21 Honeysuckle Drive - Newcastle

State Significant
Development
Modification Assessment
(SSD 8019 MOD 1)

August 2019

Figure 5 | Proposed Site Plan (Source: DA-0103 Rev 17 dated 15.05.19)

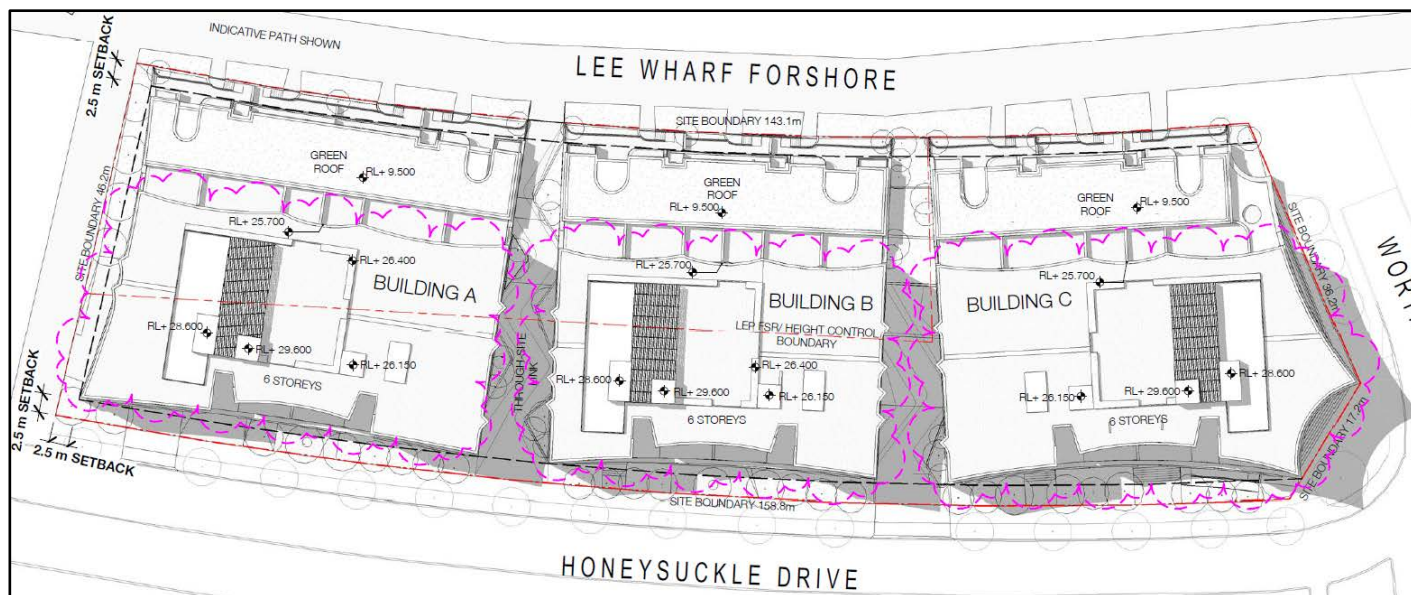
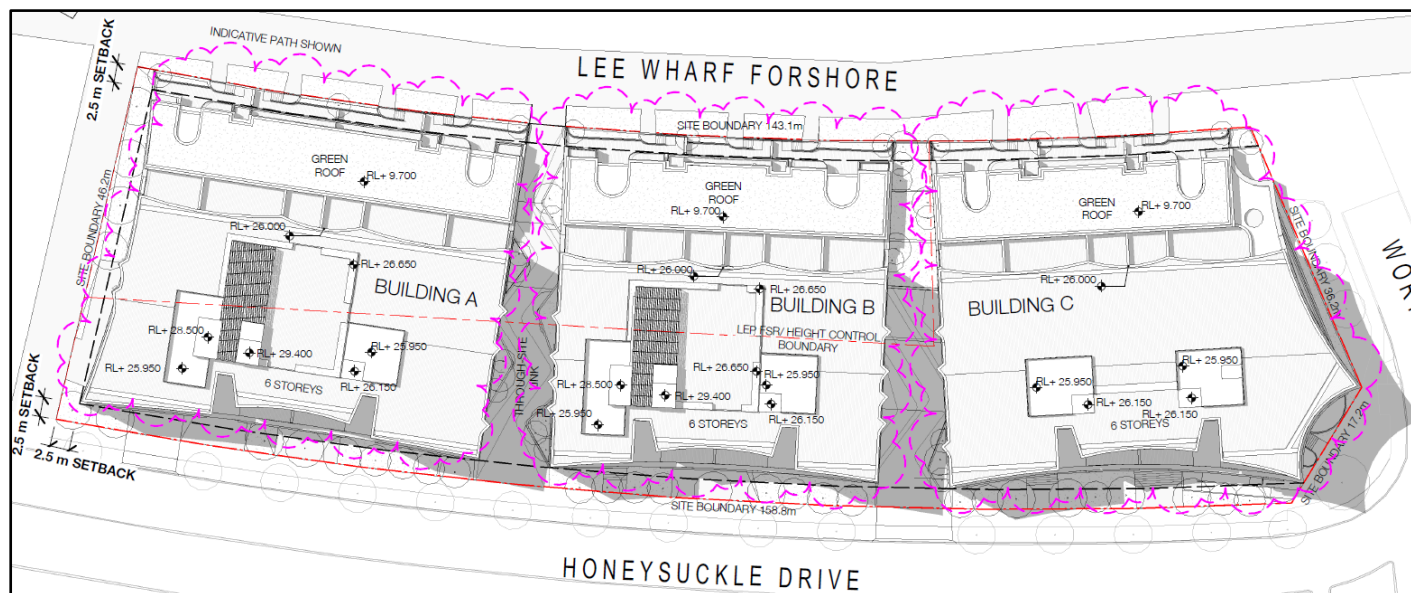
- reconfiguration and amalgamation of 12 apartments into 6 apartments and a reduction in the of the number of adaptable apartments from 16 to 15.
- removal of 30 AC condenser rooms to provide additional internal storage for 1-bedroom apartments, resulting in a 176m² increase in Gross Floor Area (GFA)
- amendments to the roof structure relating to the height of the parapets, plant items and lift overruns, including the following changes:
 - height of rooftop plant increase by 1050mm
 - parapet increase by 300mm
 - plant increase in height by 250mm
 - lift overrun decrease in height by 200mm

- o level 2 terrace roof increase by 200m
- amendment to Conditions B23 and B24 relating to the Probable Maximum Flood (PMF) design level from RL 3.65m to RL 3.4m.
- deletion of Condition F5 relating to anti-graffiti paint.

Figure 10 | Approved (right) and proposed (left) ground floor commercial tenancy layout (Source: SSD 8019 Approved Plans and SSD 8019 MOD 1 Plans)

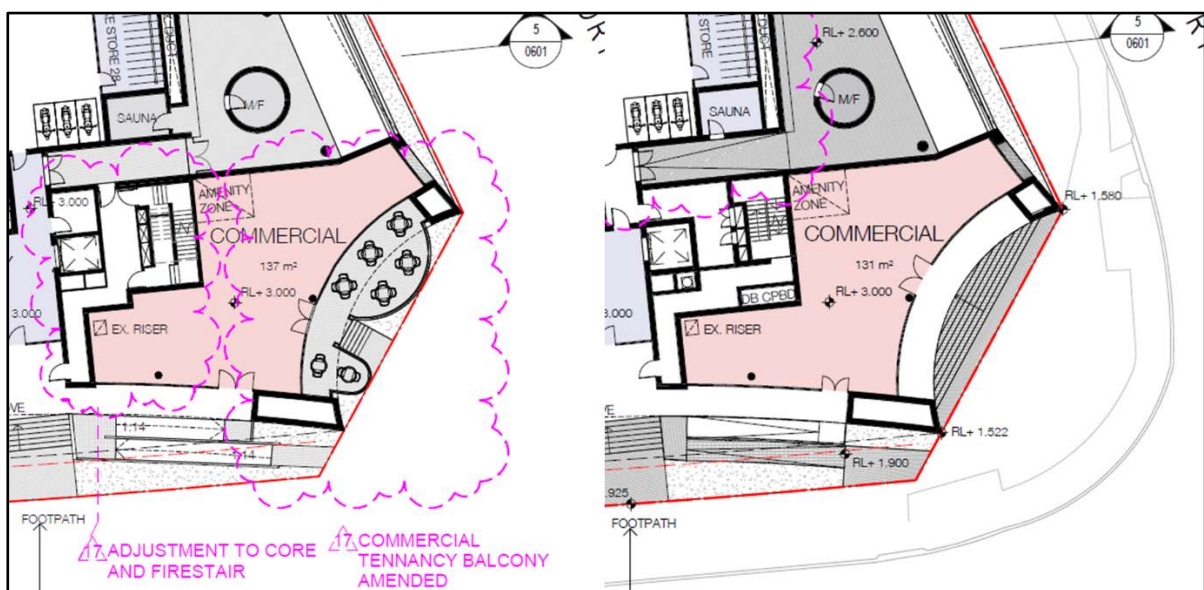
- extension of the commercial tenancy balcony on the corner of Worth Place and Honeysuckle Drive to create outdoor seating (**Figure 10**)
- minor façade amendments including the addition of bay windows on Building A
- the floor area of the 11 approved additional carparking spaces included as GFA
- details about parking, solar compliance, adaptable apartments and GFA calculations were added to the plans.

On 22 July 2019, the Applicant provided additional information to revise the proposed external brick work from white brick to terracotta finish material and confirmed the proposed ground floor tenancy balcony is open and would not create any additional GFA.

balcony	<p>Honeysuckle Drive to provide 42m² of outdoor seating.</p> <ul style="list-style-type: none"> • The Applicant advised the outdoor balcony seating would not be enclosed and would not therefore create any additional GFA. • The Department considers the proposed outdoor seating area to be acceptable as: <ul style="list-style-type: none"> ○ access would continue to be provided by the front stairs and side ramp ○ outdoor seating is not expected to have any amenity impacts, with nearby ground floor developments also being used for retail/commercial uses ○ outdoor seating would activate the corner street frontage management issues associated with noise and hours of operation would be dealt with under a separate DA for the fit out and use. 	<p>amendments necessary.</p> <ul style="list-style-type: none"> • Existing Condition A3 provides that separate DAs must be lodged, and consent obtained for retail, commercial and café works and uses.

Figure 12 | Proposed (top) and approved (bottom) Building C elevations (Source: SSD 8019 Approved Plans and SSD 8019 MOD 1 Plans)

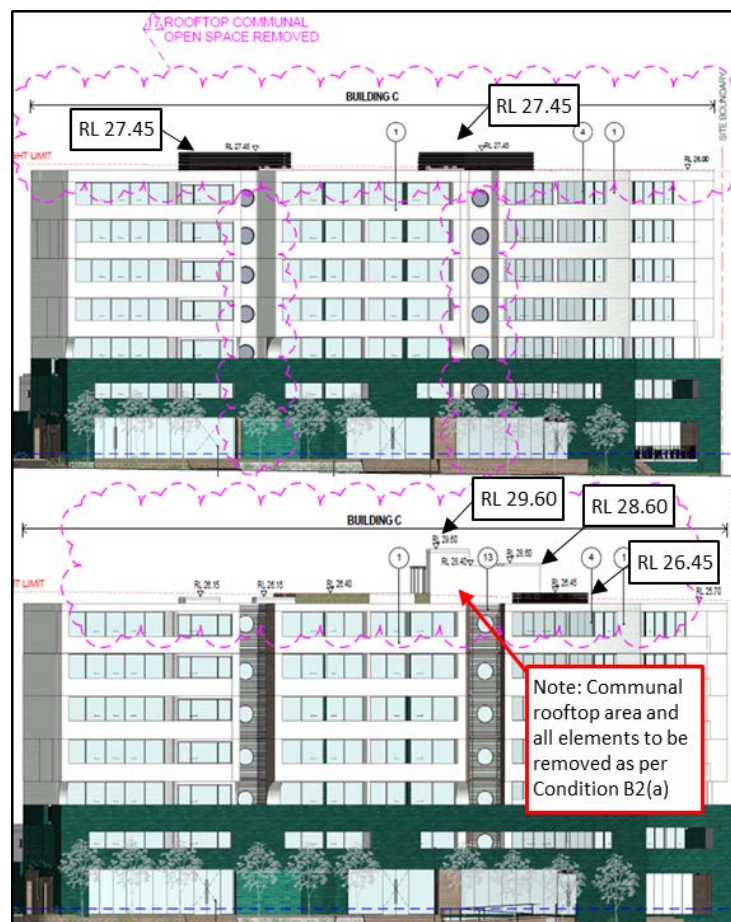
- the height of the communal open space pergolas on Buildings A and B would increase by a maximum of 0.12m above the previously approved 26.11m height. This would result in a minor further non-compliance with the 14m NLEP height control, however the Department considers the additional exceedance to be acceptable as it is minimal and there are no discernable visual or amenity impacts.
- the new rooftop plant boxes on Building C would exceed the 24m NLEP height control by 1.13m (4.7%), are setback from the façade of the building and also have a negligible visual impact. See **Figure 12**.

The SSD approval included a condition requiring the communal rooftop area and associated structures on top of Building C to be removed due to view loss impacts. While the communal rooftop area and majority of roof top structures would still be removed, the height of the rooftop plant would increase. As such the Department requested the Applicant provide further justification to demonstrate the suitability of locating plant on Building C.

The Applicant advised it explored alternative locations for the AC condenser units and plant, however the proposal is considered the most appropriate from a serviceability, architectural design and amenity perspective.

- the increase in height is minor and the plant is located in the centre of the rooftop and well setback from the site boundaries. As such, it would not have an adverse visual impact when viewed from the street or any neighbouring properties
- it would not generate any unacceptable amenity impacts with respect to view loss (discussed further in **Section 5.3**) or noise (see **Section 5.4**), to nearby landowners
- the variation would not result in a development that would be out of character with the existing streetscape.

Figure 14 | Aerial photograph showing the viewpoints (Source: Built Form Analysis by SJB Architects)

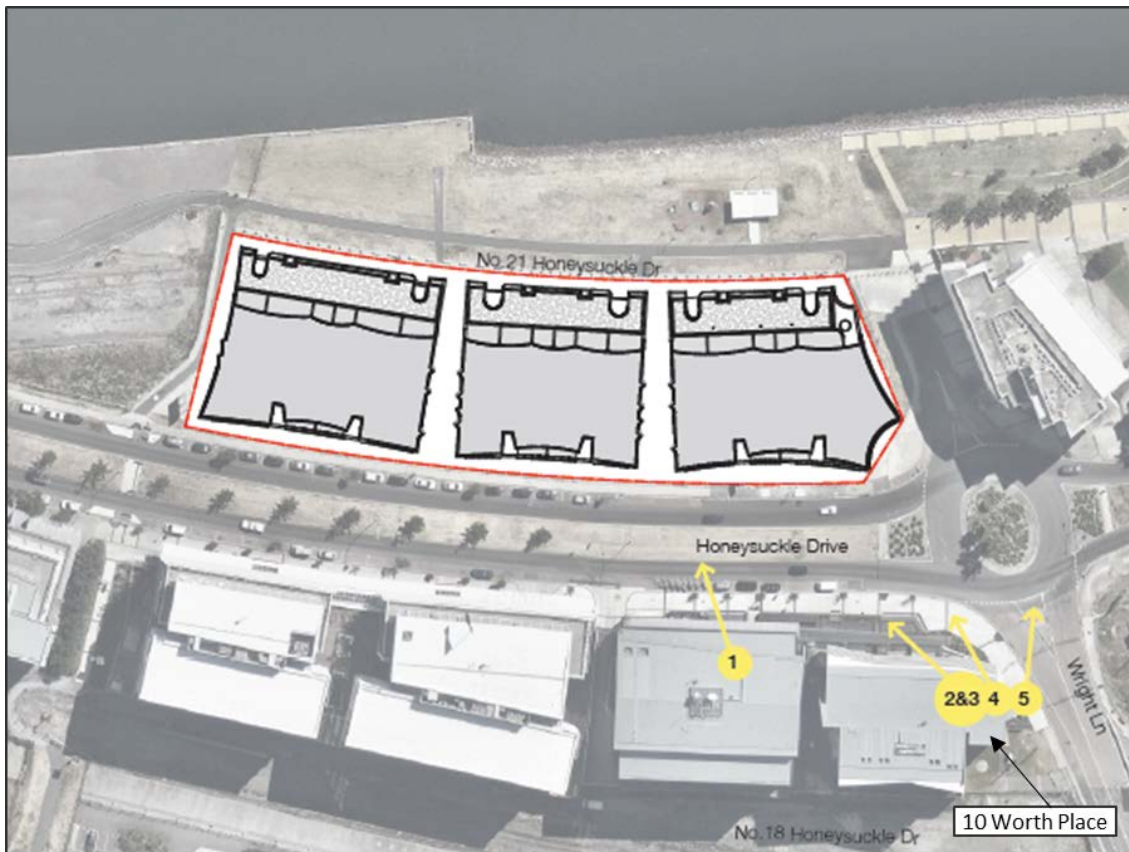
The view assessment demonstrates that from levels 7 and below, the impacts of the modification would not be significant. At locations 2 and 4 on level 9, the overall appearance of the site remains similar. There is a marginal loss of strips of water views as a result of the plant on Building C. Views of the district, horizon and areas of water towards the Hunter River are retained.

1. The affected views: The affected view is not an iconic view. While it includes narrow tracts of water views of the Hunter River/Throsby Creek above Building C (as shown in **Figure 15**) the overall view is dominated by sky views and the approved development in the mid and foreground.

- two tracts of Throsby Creek/Hunter River water view in the background of Building C would be lost.
 - a small portion of district land views to the west would be lost.

Based on the above assessment, and a detailed consideration of view impacts from the most affected floors at 10 Worth Place, the Department is satisfied that the view loss impacts are reasonable. In this regard, the overall view loss impacts are considered negligible compared to the approved development.
